ROYAL BERKSHIRE HOSPITAL – UROLOGY OPC

ACOUSTIC DESIGN REPORT

AEC REPORT: P5281/R01a/DMT

Image 4.1 – Roof Detail

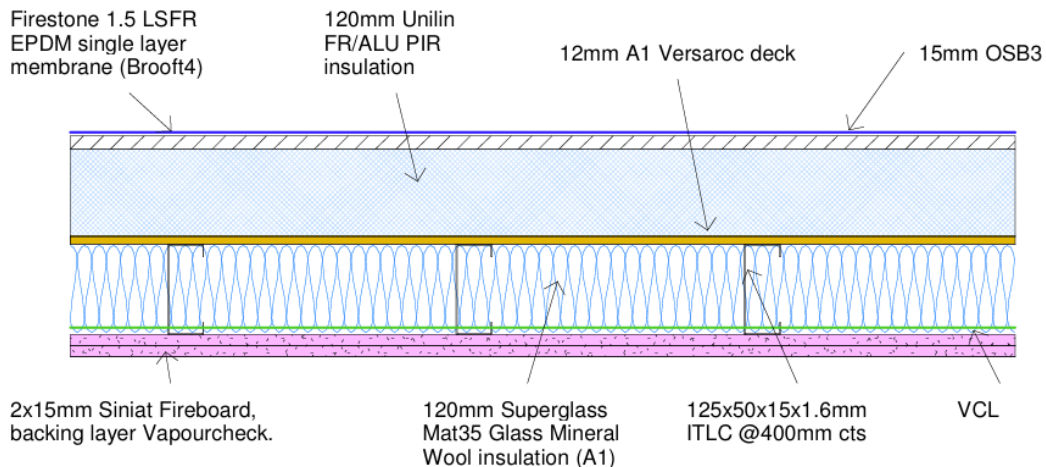
- 4.7 Acoustic predictions indicate a sound insulation performance of approximately 54dBR_w. Therefore, the roof structure should reduce airborne noise to suitable internal levels, provided any external plant is not generating excessively high levels of low frequency noise.

Partition Type P7 & P8 – Suitable for $47\text{dBD}_{\text{nT,w}}$ On-site

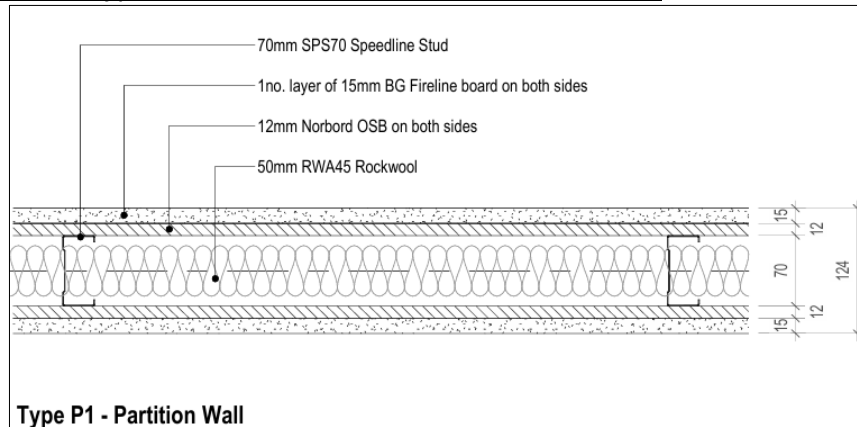
- 5.6 Based on Insul© prediction software calculations and test data for similar constructions, it is likely that these two partitions would have a sound insulation performance of approximately 52-54dBR_w. Therefore, these partition would be suitable where an on-site requirement of 47dBD_{nT,w} (or lower) is required.
- 5.7 However, to achieve 47dBD_{nT,w} on-site with these partitions, it will be necessary to ensure good junction detailing and well-sealed service penetrations where they cannot be avoided. A high level of workmanship will be required, and unsealed doors can limit on-site sound insulation performance. Crosstalk (sound transfer via ductwork) will also need to be controlled.

Flanking via floor / partition base (47dBD_{nT,w})

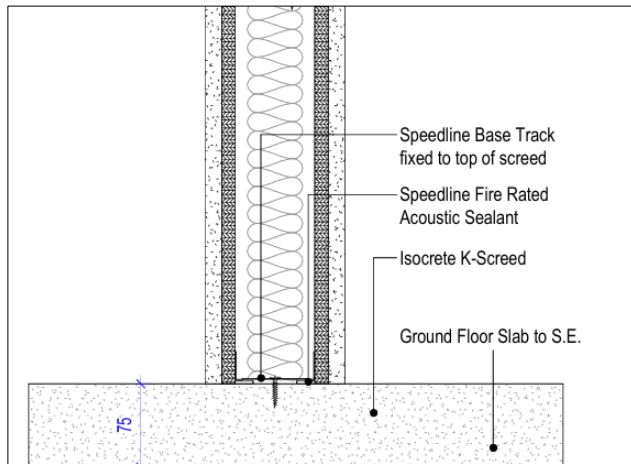
5.30 The based junction detail is provided below.

5.31 This detail will be suitable for all partitions provided it is suitably sealed at the junction before the floor coverings are applied.

Flanking via corridor partitions (47dBD_{nT,w})

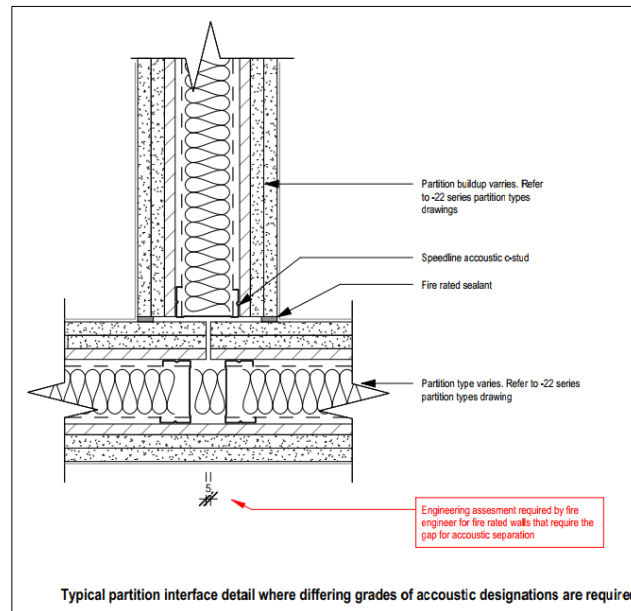
5.32 No corridor wall junction detail has been provided.

5.33 The above example junction detail, where the flanking wall lining has a break, is suitable where separating partitions are required to achieve $\geq 47\text{dBD}_{nT,w}$ on-site. Where $42\text{dBD}_{nT,w}$ or less is required on-site, then the flanking partition does not need to be broken, provided the lining of the flanking partition is 2 or 3 layers and there is mineral wool in the cavity.

Flanking via external wall

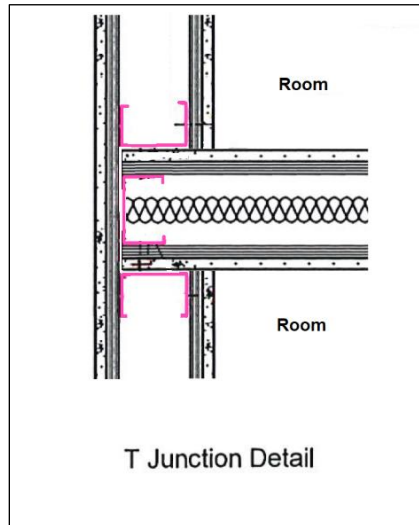
- 5.34 Ideally, where the separating partitions meet the external wall lining, the separating partition would break through and close the flanking cavity (see below). Or, a break would be provided, as per the corridor wall junction detail above. No specific external wall junction detail has been provided.

- 5.35 If the internal lining of the external wall cannot be broken then this would be a potential weak flanking path. It appears that the internal lining of the external wall is only 1 layer of 15mm Siniat LaDura board. This has a mass of 15kg/m². AEC would recommend at least 20kg/m² i.e. two layers of board. Proceeding with one layer of board would be a marginal situation in terms of achieving 47dBD_{nT,w} between the small consultation/examination rooms.

APPENDIX D – Partition Mark-Up

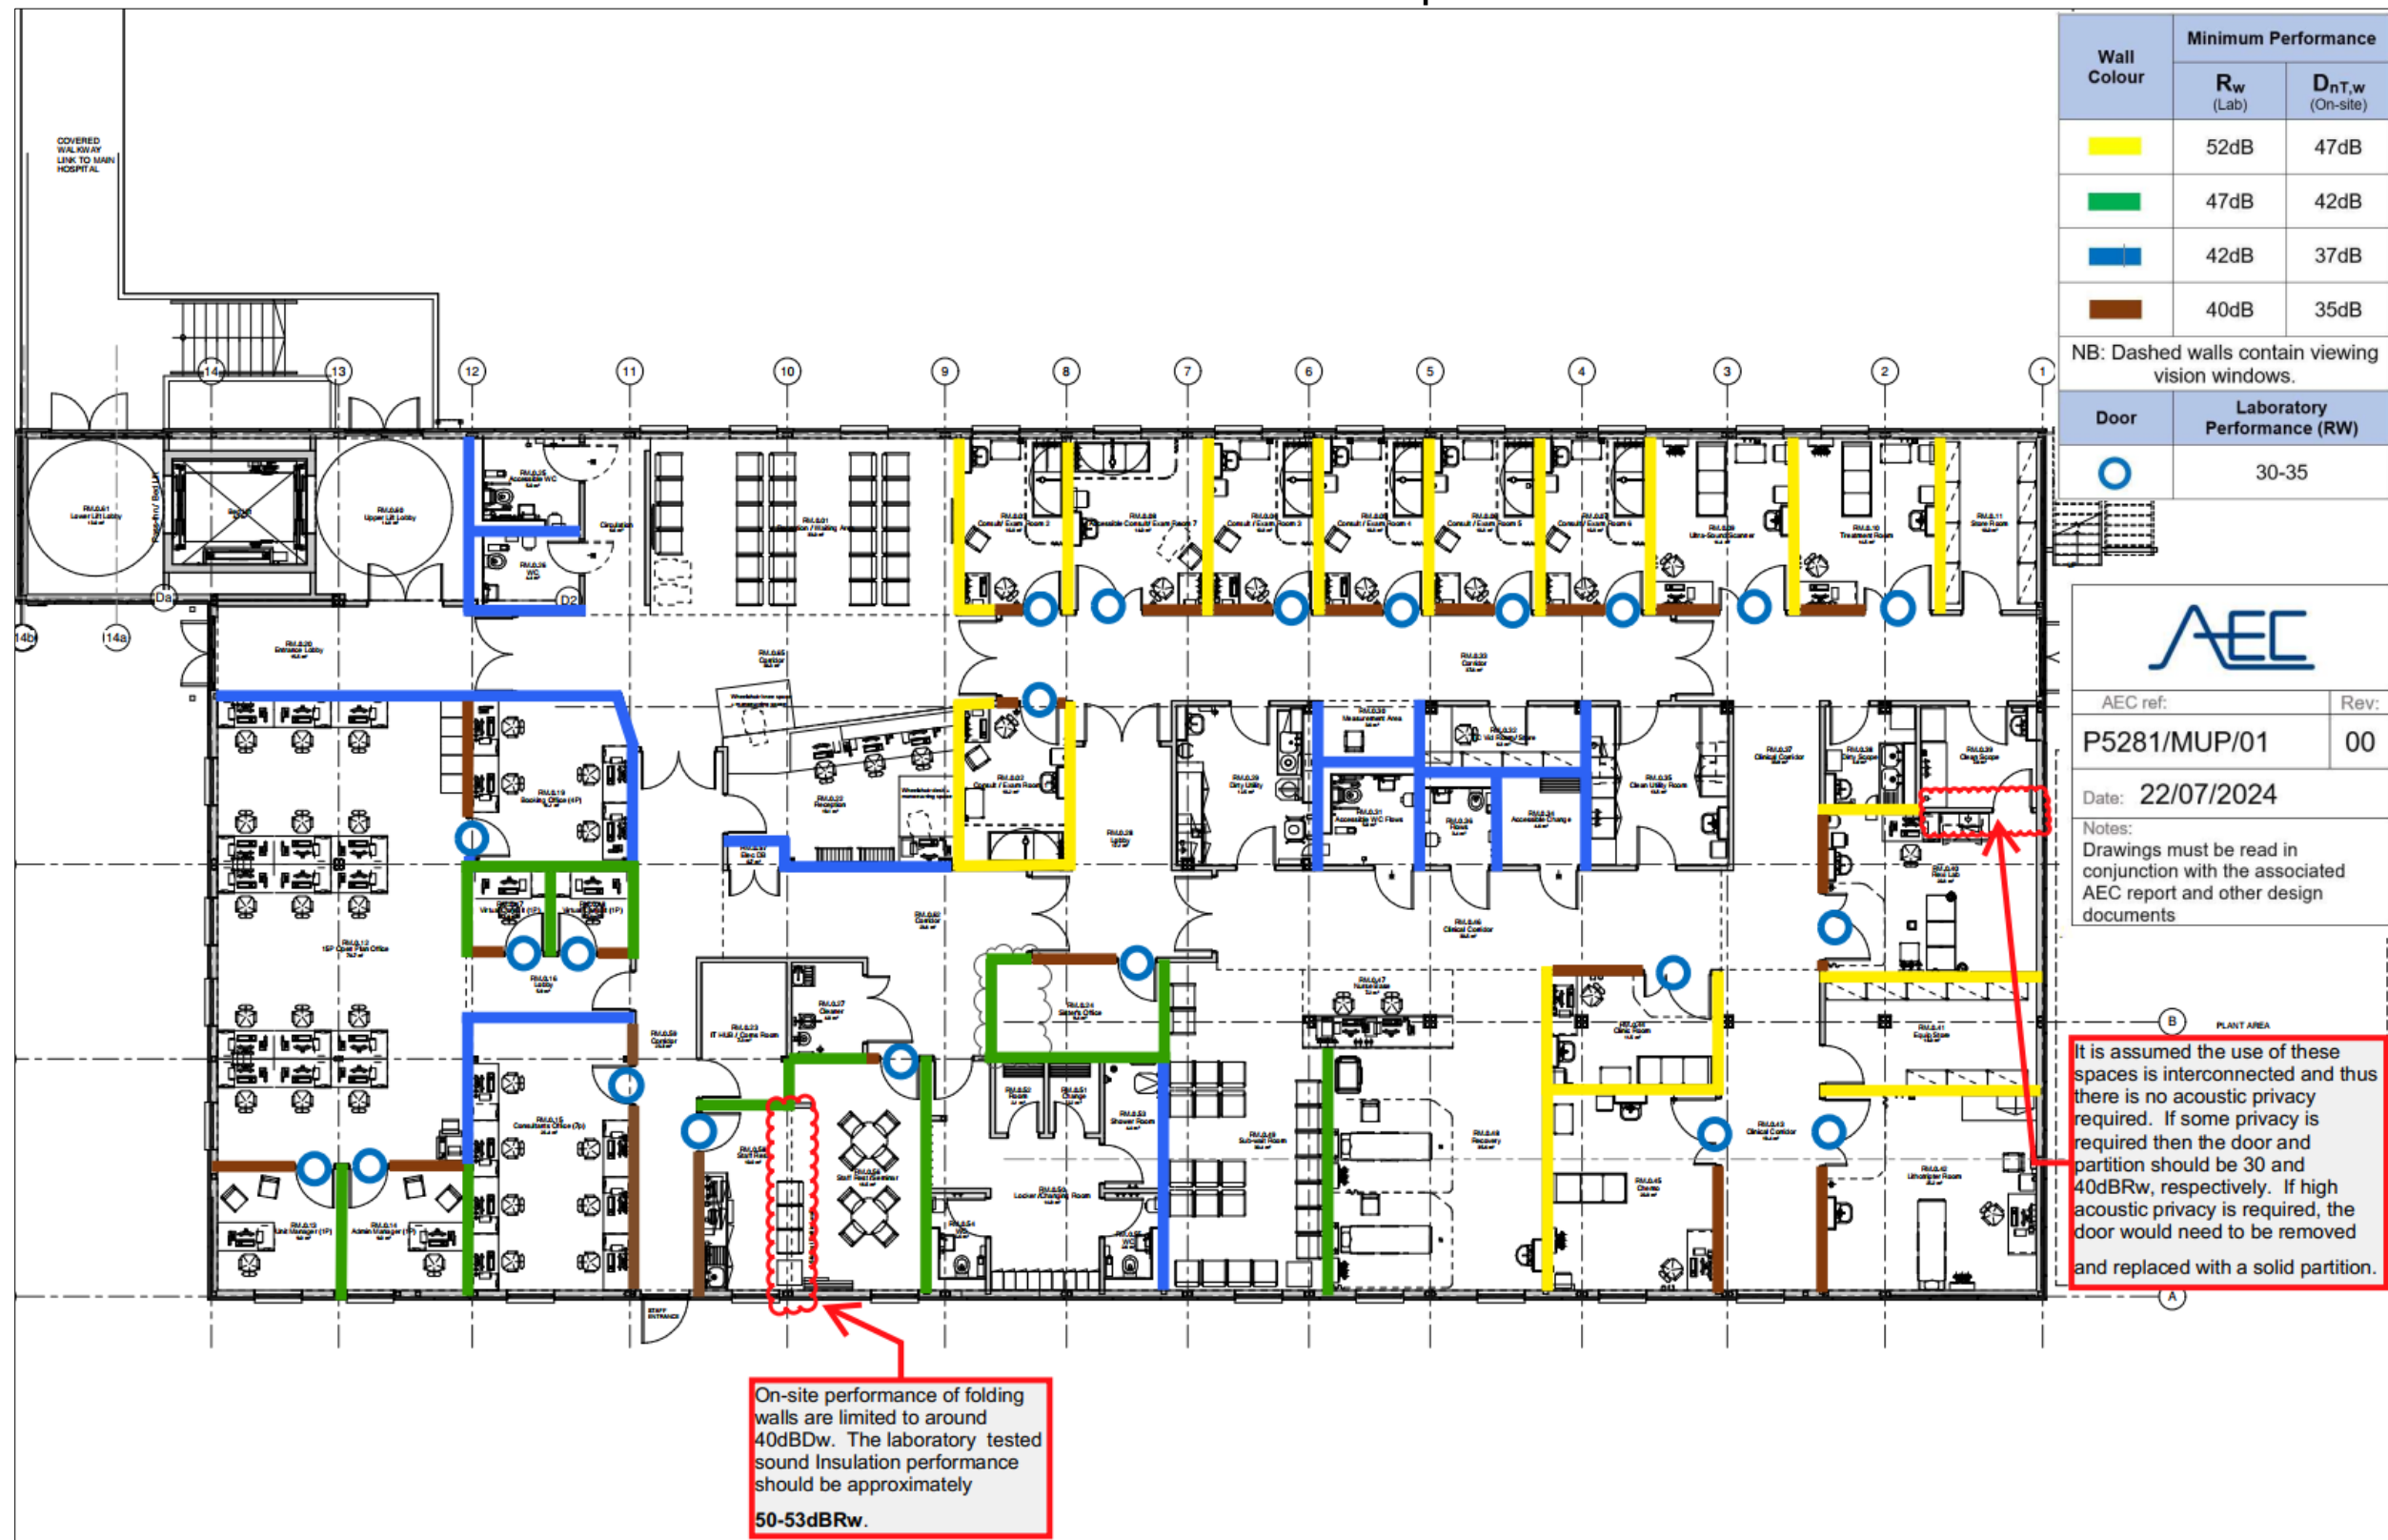
- 2.9 The above table is not an exhaustive list of all adjacencies. Reference should be made to Table 5 of HTM 08-01 for other specific adjacencies and **AEC's partition mark-up in Appendix D**. The mark-ups are also available in higher resolution PDF format and have been issued separately.
- 2.10 Corridor walls with a door to a noise sensitive room, will be limited by the acoustic performance of the door. In these instances, walls should be rated at least 40dBR_w as show on the mark-ups in Appendix D (including glazed elements).

APPENDIX E – Indicative Assessment of Crosstalk Attenuators

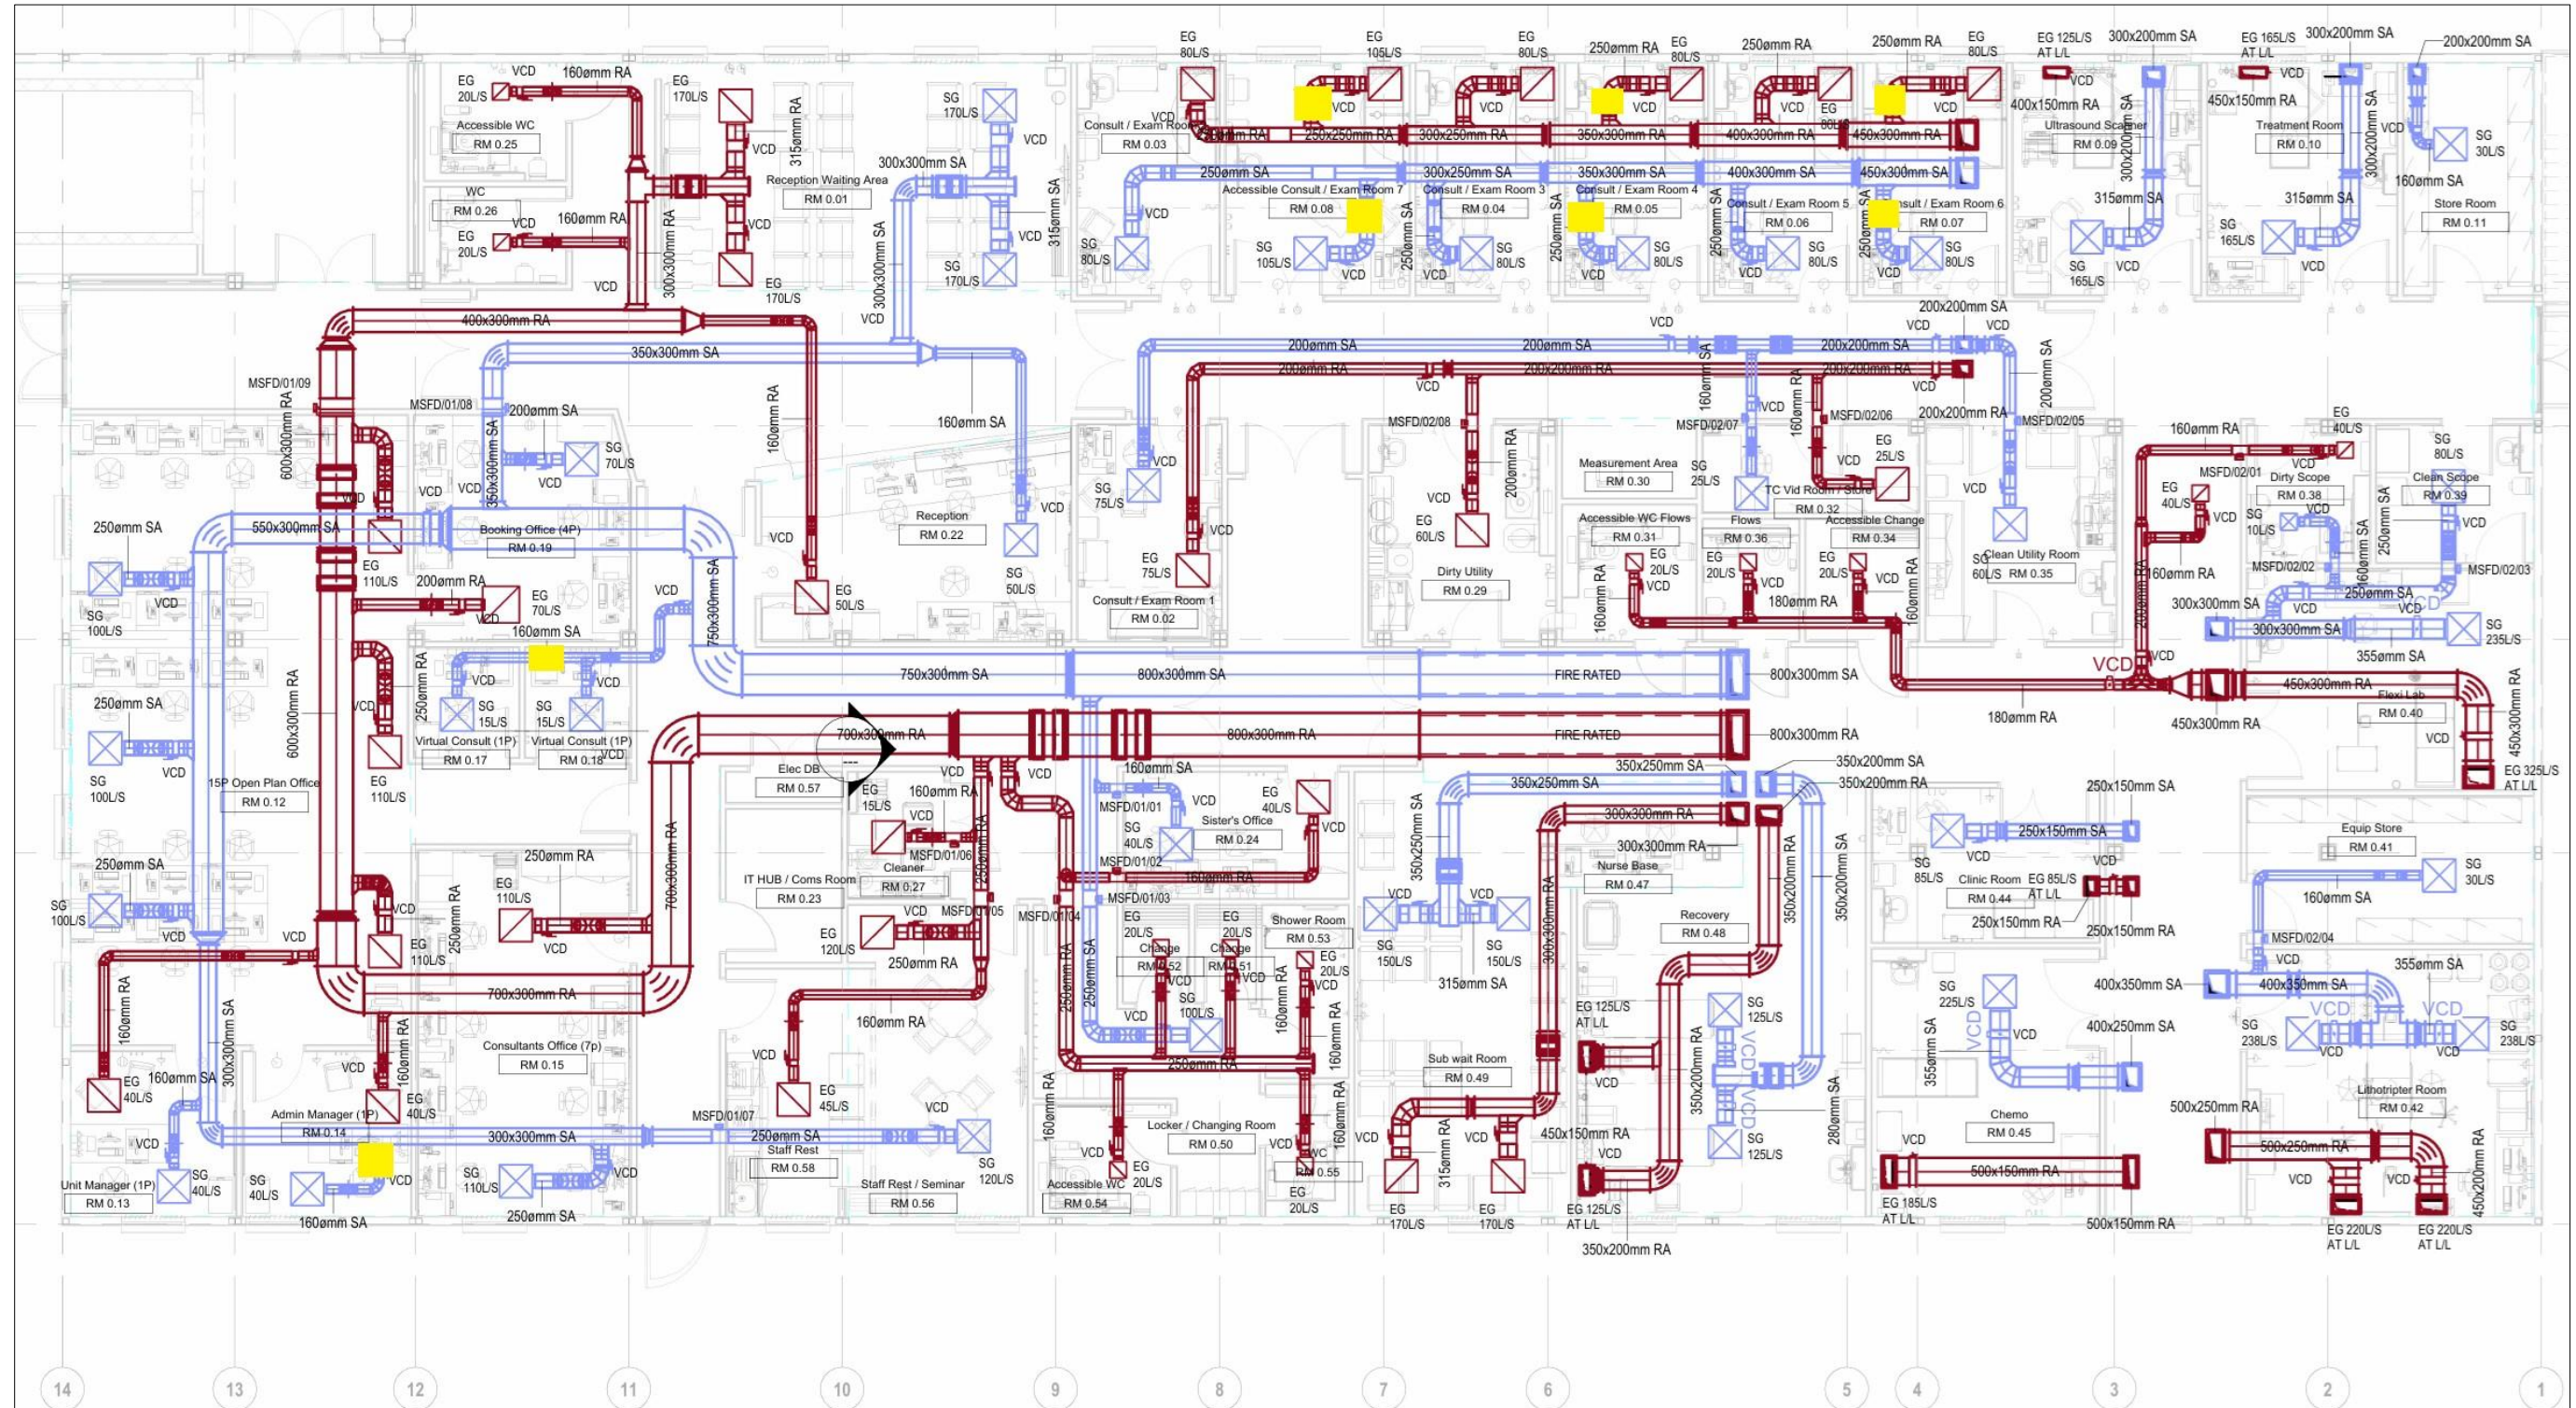
- 7.3 As identified above, the design of the mechanical services system must allow for appropriate cross talk attenuation. AEC has reviewed the M&E ventilation layout and highlighted indicative locations where crosstalk attenuators should be considered. **These are indicated in Appendix E.**

N.B. Eight Areas have been identified above (with a yellow box) where crosstalk attenuators (300mm) would be beneficial, if practicable to include
